Access Compliance Report Public Rights-of-Way (Pedestrian Signals)

Main Street: **OSO_PKWY** Cross Street: **MEANDERING_TRAIL** Location: **SE**

ADA ID: **SGRK211019151458** Signal Type: **One Push Button-APS** Overall Compliance: **No** Severity Scores: **BTN 1: 25** **BTN 2: N/A** **No BTN: N/A**

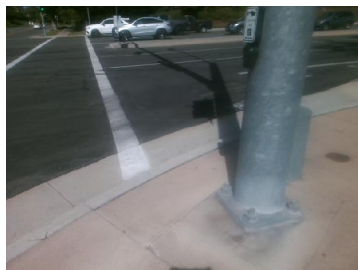
OC Std/PROW: **R404.2, R404.3**

Possible Solutions: Remove and Replace Clear Space.
